**PITT STREET FAÇADE TREATMENT
STUDY**

1 ALFRED STREET, SYDNEY

3.6 AMENDMENTS AND CONSIDERATIONS

3.6.1 FOUR DIMENSIONAL FRAME ELEMENT

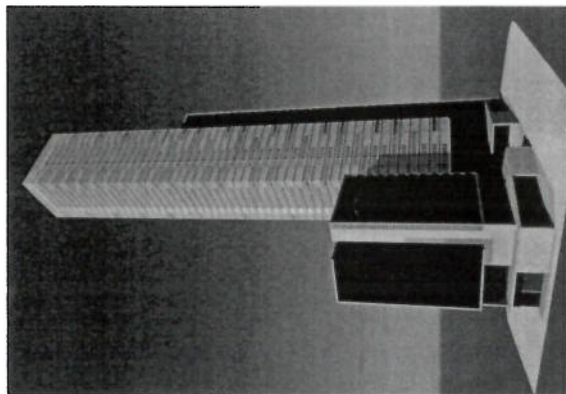
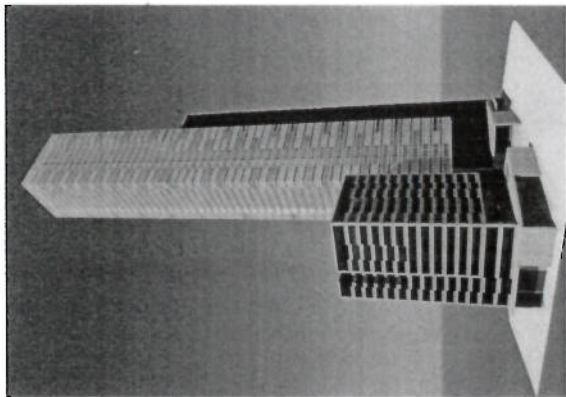
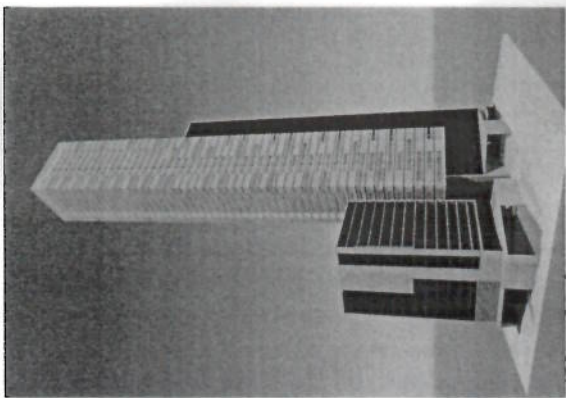
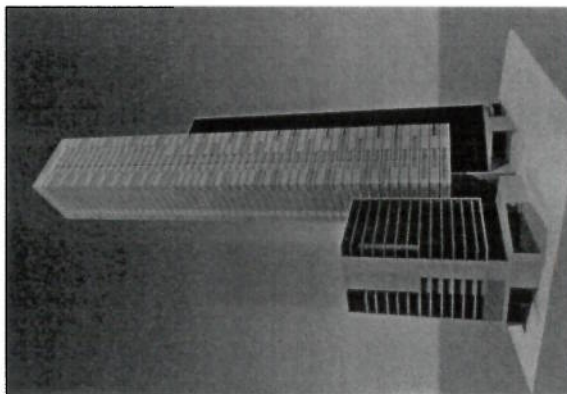
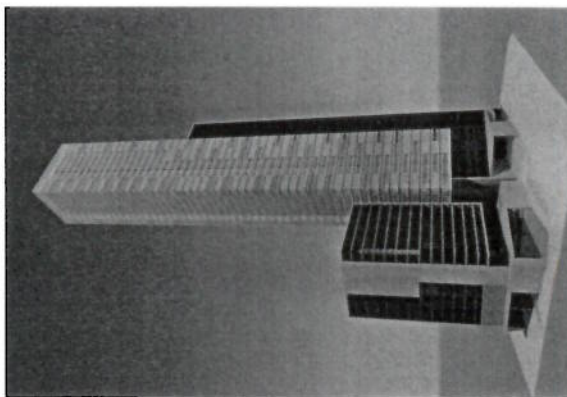
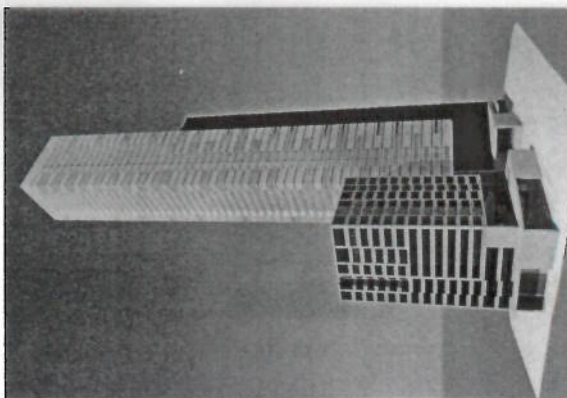
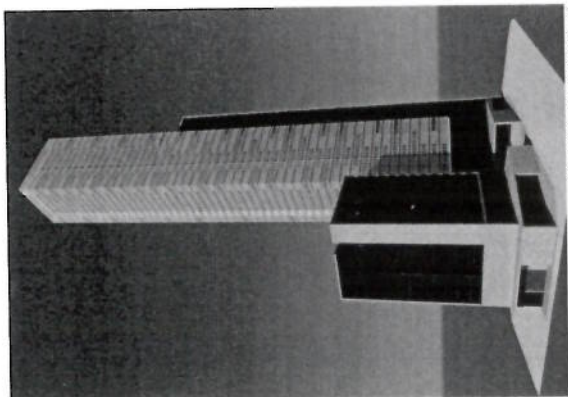
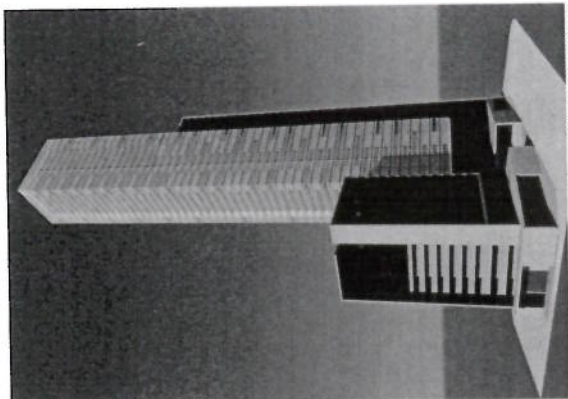
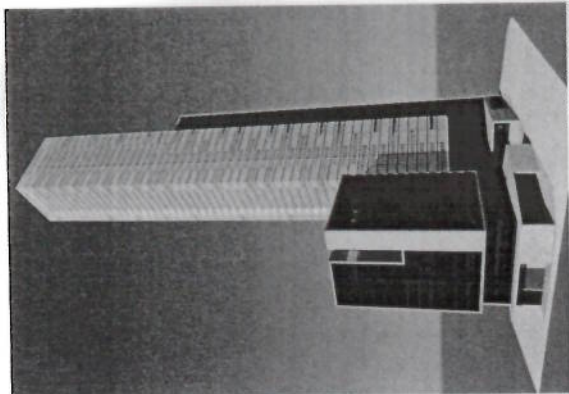
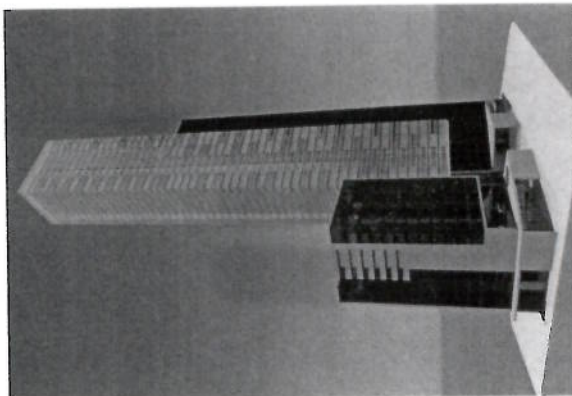
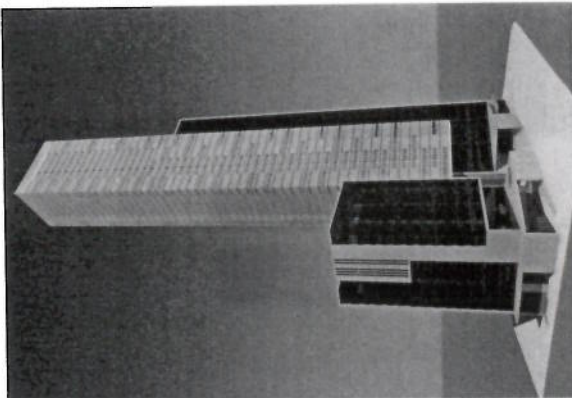
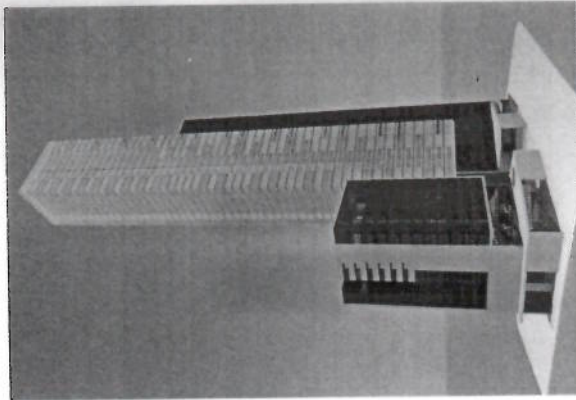
Issue	Discussion	Conclusion
The party/jury requested that KHA consider reinstalling the masonry walls to the east of Building B	<p>During the design development of the project, the brief evolved to require views from the apartments to the east side of the low rise tower.</p> <p>KHA explored a number of options to provide discrete openings in the masonry wall to the east. Figures 17 - 28 record the exploration process.</p>	<p>It was concluded that none of the design options with discrete openings were as architecturally successful as providing a glazed expression to the east elevation of the low rise tower.</p> <p>KHA believe that the glazed expression is an acceptable design solution that retains the integrity of the scheme.</p>
